## **SOLICITATION AMENDMENT MODIFICATION DE L'INVITATION**

<b>Title - Sujet</b> CCTV EQUIPMENT AT MILLHAVEN	
<b>Solicitation No. - N° de l'invitation</b> 21120-147892/A	<b>Amendment No. - N° modif.</b> 003
<b>Client Reference No. - N° de référence du client</b> 21120-14-2007892	<b>Date</b> 2015-03-04
<b>GETS Reference No. - N° de référence de SEAG</b> PW-\$\$HN-461-66520	
<b>File No. - N° de dossier</b> hn461.21120-147892	<b>CCC No./N° CCC - FMS No./N° VME</b>
<b>Solicitation Closes - L'invitation prend fin</b> <b>at - à 02:00 PM</b> <b>on - le 2015-03-13</b>	<b>Time Zone</b> <b>Fuseau horaire</b> Eastern Daylight Saving Time EDT
<b>F.O.B. - F.A.B.</b> <b>Plant-Usine:</b> <input type="checkbox"/> <b>Destination:</b> <input type="checkbox"/> <b>Other-Autre:</b> <input type="checkbox"/>	
<b>Address Enquiries to: - Adresser toutes questions à:</b> Hallman, Patti	<b>Buyer Id - Id de l'acheteur</b> hn461
<b>Telephone No. - N° de téléphone</b> (819) 956-7390 ( )	<b>FAX No. - N° de FAX</b> ( ) -

*Amendment 003 is issued to address the time zone change and to answer additional questions received.*

## **Questions and Answers Part 3**

Attached is a site map for reference, (this map also located in Appendix H)

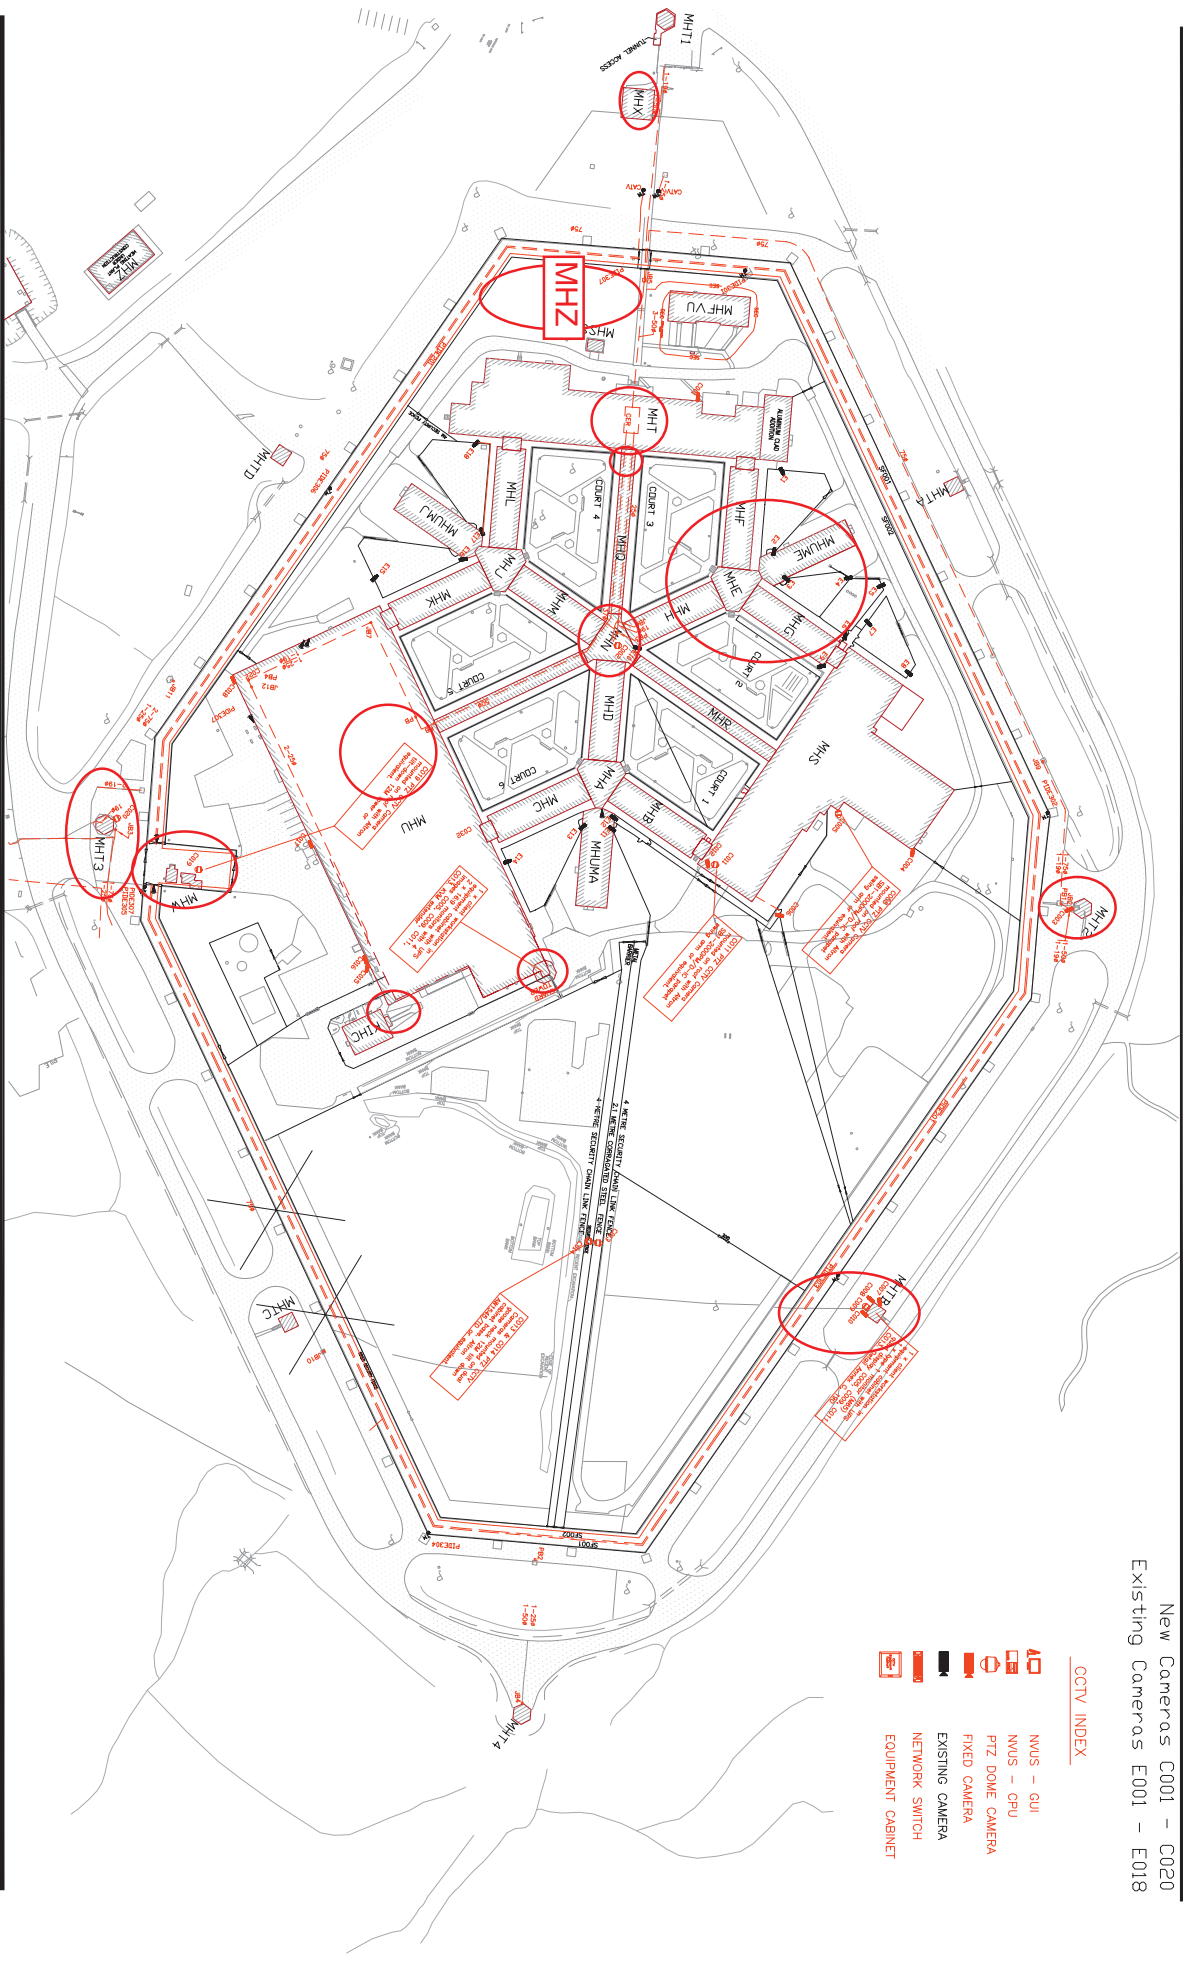
Some points of interest in today's site bidders meeting.

Corresponding map identified in red

1. GI building (MHZ)
2. T building (MHT)
  - T169
  - M CCP
  - V&C
  - CER
  - Main
3. N control (MHN)
  - N basement
  - A basement
  - E basement
  - J basement
  - E control
4. E unit (MHE)
  - E unit management offices
  - 1G
5. S building (MHS)
  - S control
  - S basement
  - Segregation
  - Hospital
  - S Gallery
6. U building (MHU)
  - U control
  - U gallery
  - Kitchen gallery
  - U tower
7. ID building (MHX)
8. 2 Tower (exterior only)
9. B outpost (interior)
10. 3 Tower (exterior only)
11. Sally port (MHW)

New Cameras C001 - C020
Existing Cameras E001 - E018
